Appendix E – Approval Letter of Tree Removal Application and Tree Schedule

Contract No. HY/2013/02
Hong Kong-Zhuhai-Macau Bridge (HZMB)
Hong Kong Boundary Crossing Facilities (HKBCF) –
Infrastructure Works Stage I (Western Portion)
Tree Removal Application

TREE ASSESSMENT SCHEDULE

Tree Removal Application - Hong Kong International Airport Chek Lap Kok Lot No. 3 – Response to Comment

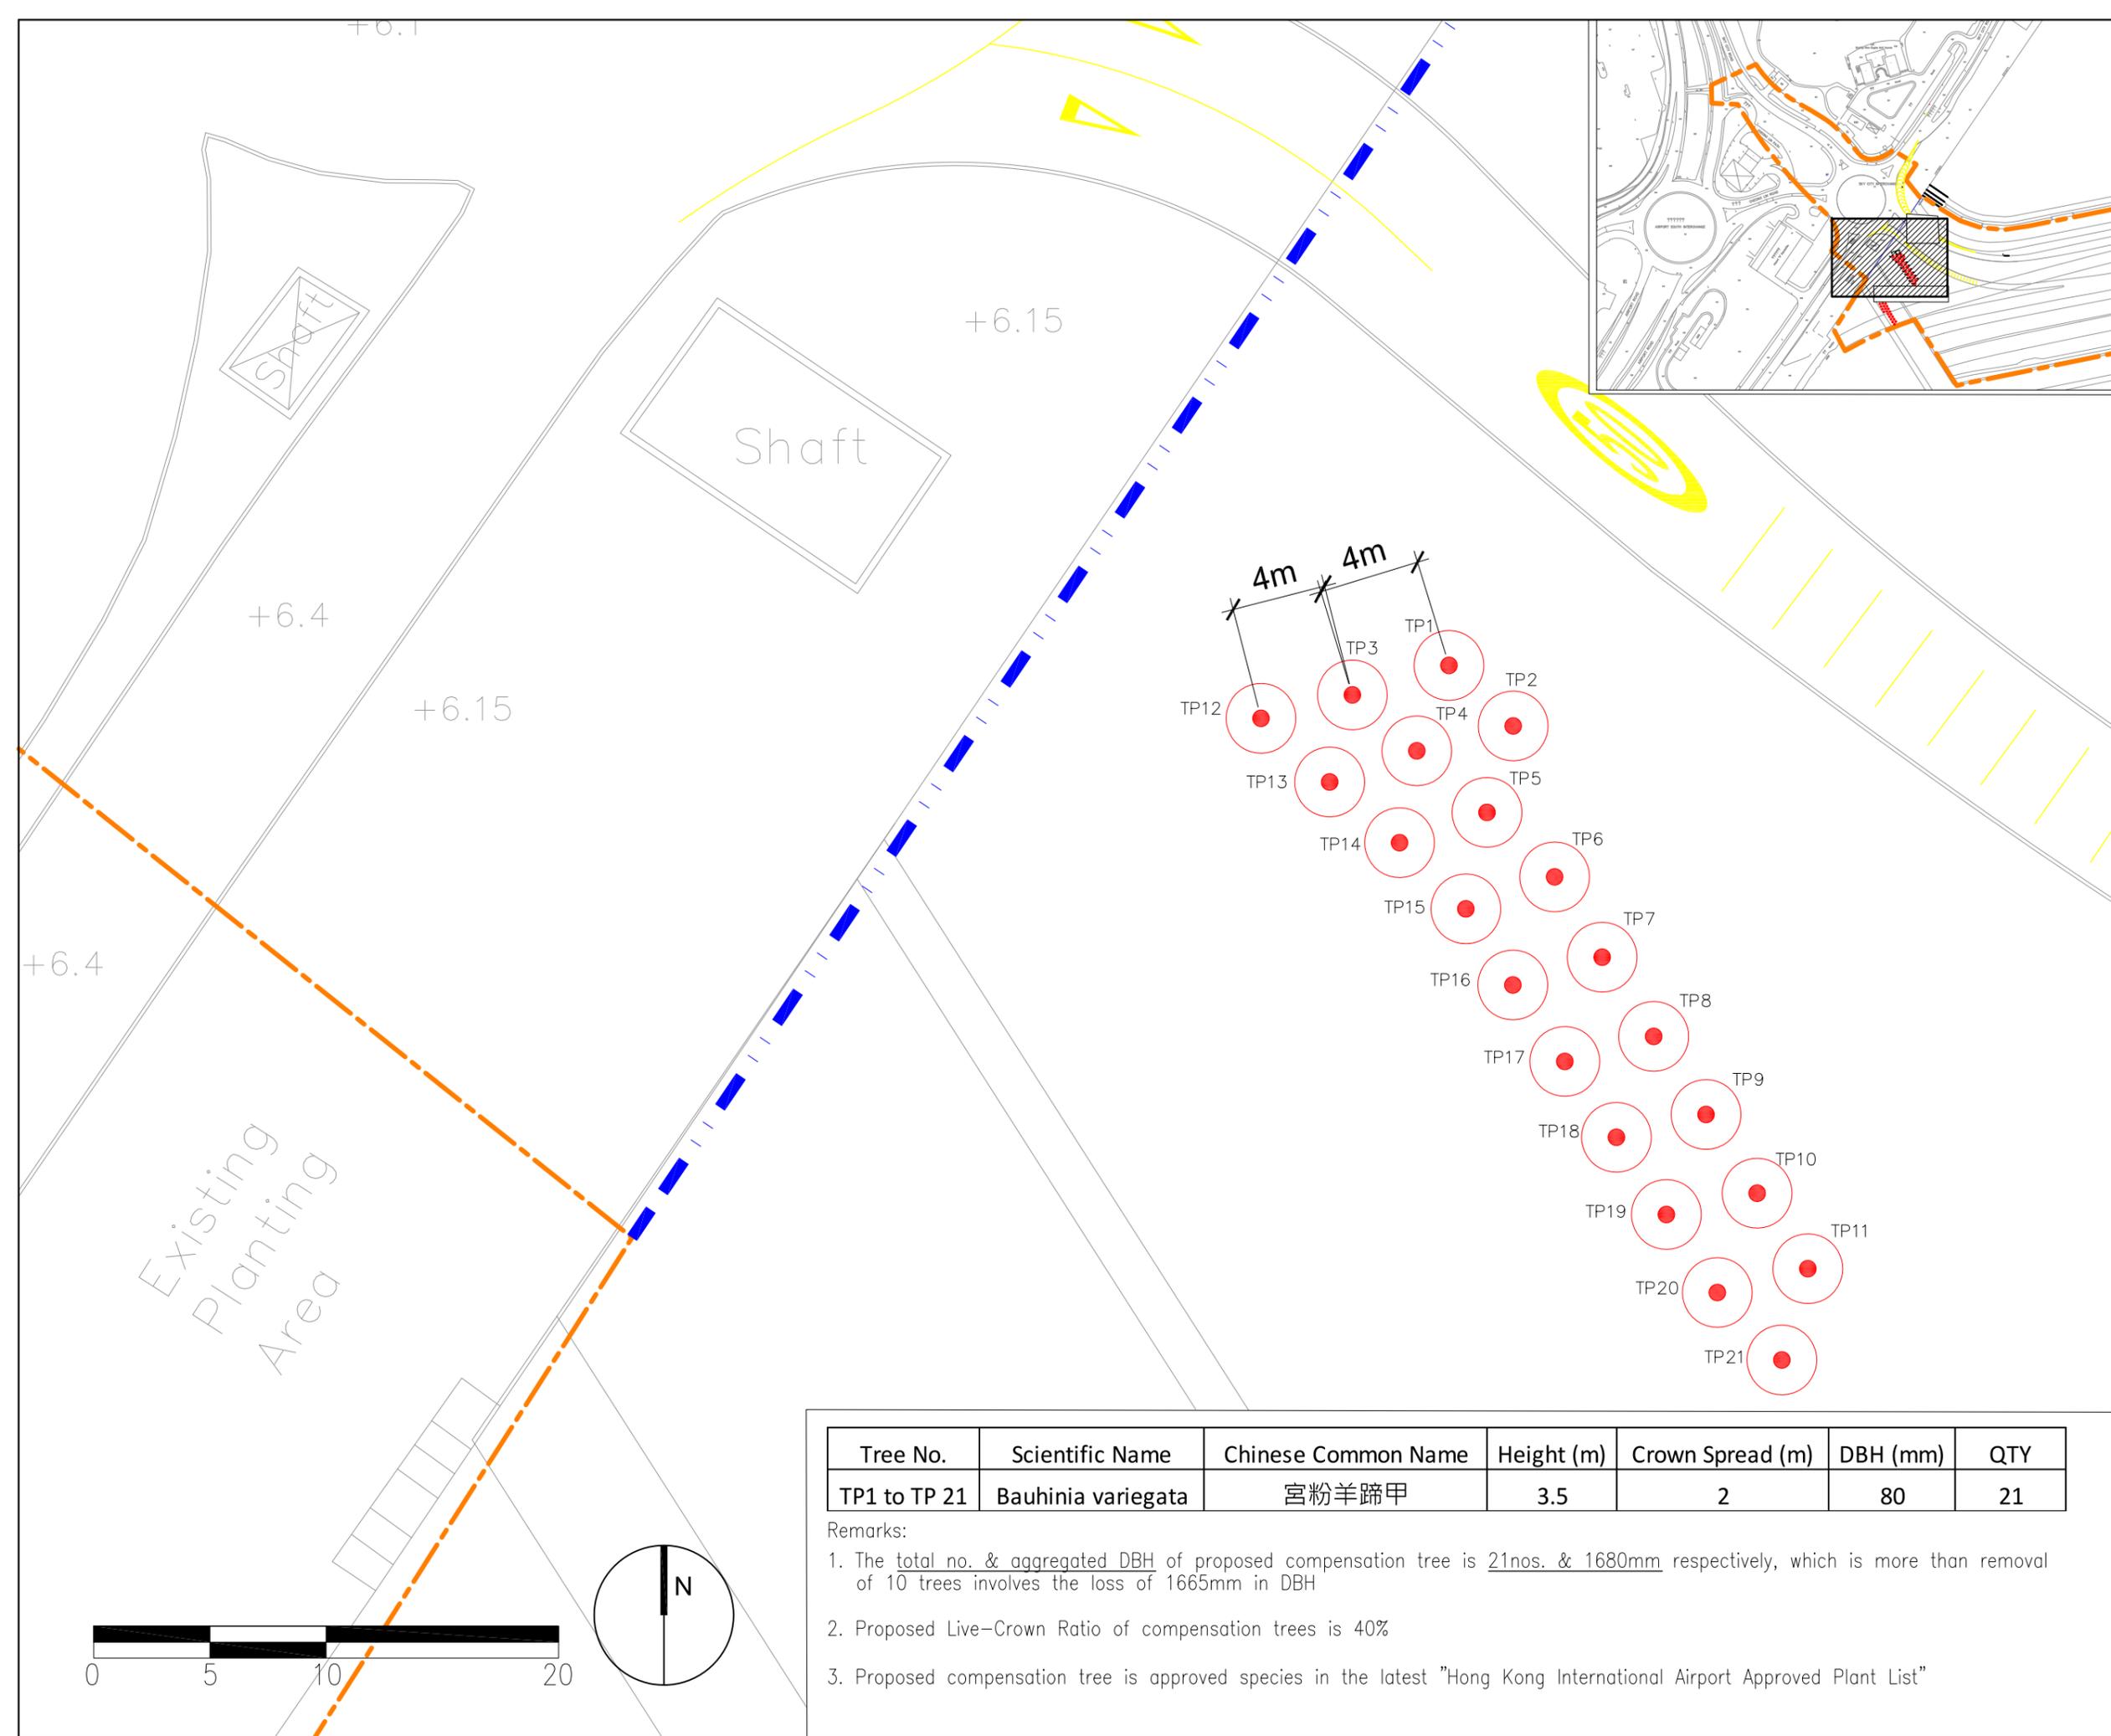
- (a) With reference to the tree assessment schedule in Appendix B of the Submission, removal of 10 trees involves the loss of 1665mm in DBH. In general principle, implementation of compensatory tree planting, of a ratio not less than 1:1 in terms of quality and quantity, within the Lot would be acceptable. That is, the total numbers and the aggregated DBH of compensatory trees within the site should not be less than that of the lost trees. While 10 nos. of compensatory trees are proposed to achieve the compensatory ratio of 1:1 in terms of quantity, HyD should clarify if the compensatory ratio of 1:1 in terms of quality will be achieved.

- (b) The schedule of the compensatory trees as shown in the compensatory planting plan in Appendix E of the Submission shall be revised with reference to the information required under Item 4(b)(vii) of Section I, Appendix II of LAO PN No. 7/2007, i.e. to specify the size in terms of DBH, crown spread and overall height. HyD shall also specify the planting spacing and live-crown ratio of the proposed compensatory tree to facilitate compliance checking in due course.

Item	LandsD/ DLO comment on 28 February 2018	Response to Comment
(a)	With reference to the tree assessment schedule in Appendix B of the Submission, removal of 10 trees involves the loss of 1665mm in DBH. In general principle, implementation of compensatory tree planning, of a ratio of not less than 1:1 in terms of quality and quantity, within the Lot would be acceptable. That is, the total numbers and the aggregated DBH of compensatory trees within the site should not be less than that of the lost trees. While 10 nos. of compensatory trees are proposed to achieve the compensatory ratio of 1:1 in terms of quantity, HyD should clarify if the compensatory ratio of 1:1 in terms of quality will be achieved.	The implementation of compensatory tree planning, of a ratio of not less than 1:1 in terms of quality and quantity is achieved. The total number and aggregated DBH of compensatory trees are 21 nos. and approximately 1680 mm respectively, which shall not be less than the compensatory ratio of 1:1 in terms of quality and quantity.

(b)	The schedule of the compensatory trees as shown in the compensatory planting plan in Appendix E of the Submission shall be revised with reference to the information required under Item 4(b) (vii) of Section I, Appendix II of LAO PN No. 7/2007, i.e. to specify the size in terms of DBH, crown spread and overall height. HyD shall also specify the planting spacing and live-crown ratio of the proposed compensatory tree to facilitate compliance checking in due course.	The schedule of the compensatory trees as shown in the compensatory planting plan in Appendix E of the Submission is revised with reference to the information required under Item 4(b) (vii) of Section I, Appendix II of LAO PN No. 7/2007. The schedule is summarized as follows: - DBH: 80 mm - Crown spread: 2000 mm - Overall height: 3500 mm - Planting spacing: 3000 mm - Live-crown ratio: 40 % Please refer to Proposed Compensatory Tree Plan (Revision C) and schedule of the compensatory trees at Appendix A as enclosed.

Tree No.	Scientific Name	Chinese Common Name	Height (m)	Crown Spread (m)	DBH (mm)	QTY
TP1 to TP 21	<i>Bauhinia variegata</i>	宮粉羊蹄甲	3.5	2	80	21

1. The total no. & aggregated DBH of proposed compensation tree is 21nos. & 1680mm respectively, which is more than removal of 10 trees involves the loss of 1665mm in DBH
2. Proposed Live-Crown Ratio of compensation trees is 40%
3. Proposed compensation tree is approved species in the latest "Hong Kong International Airport Approved Plant List"

Pursuant to our letter and e-mail dated 28 February and 7 May 2018 respectively to you on the captioned, we have no further comments on the revised Compensatory Planting Proposal Revision D (No. CHEC/R&D/LA-SE-001D) vide your e-mail dated 28 May 2018.
